## **Submissions on proposed housing in NW Bicester**

**21/01630/OUT**

**20 May 2022**

Version 3.0

### Specific response to Appendix 6.2 Travel Plan

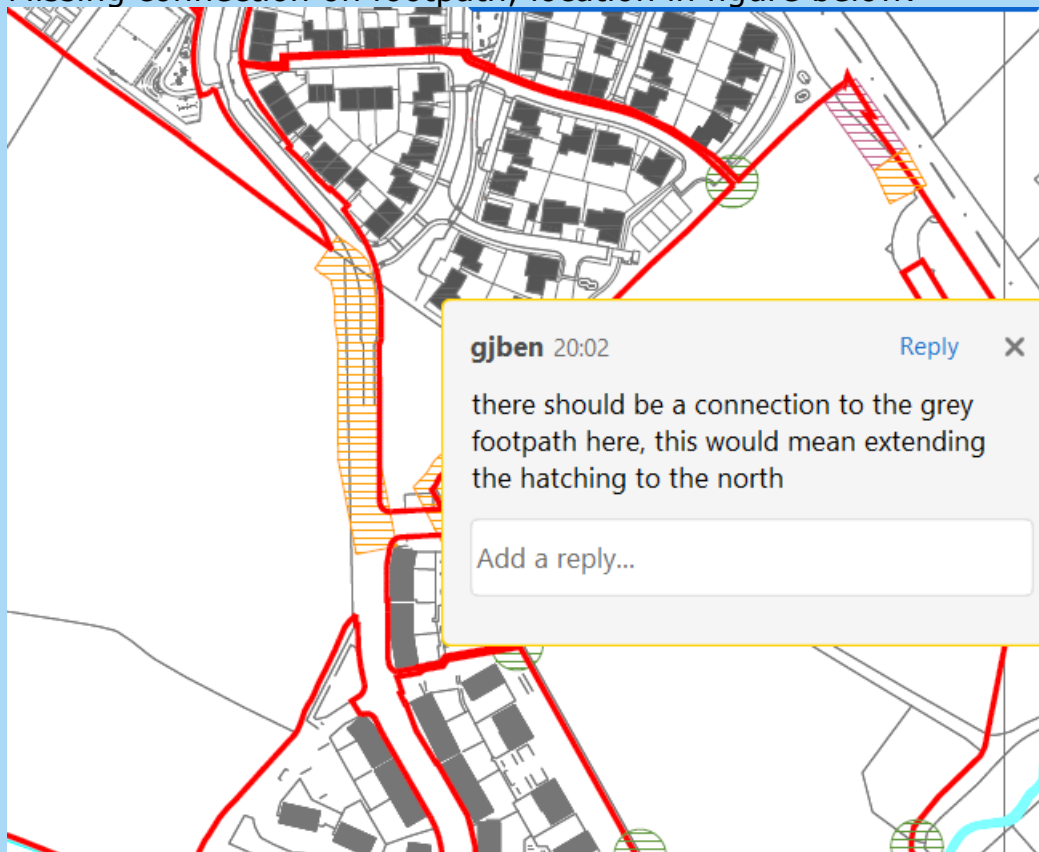
Despite numerous references to design standards and guidance, no mention is made of the latest and most important infrastructure guidance of LTN1/20
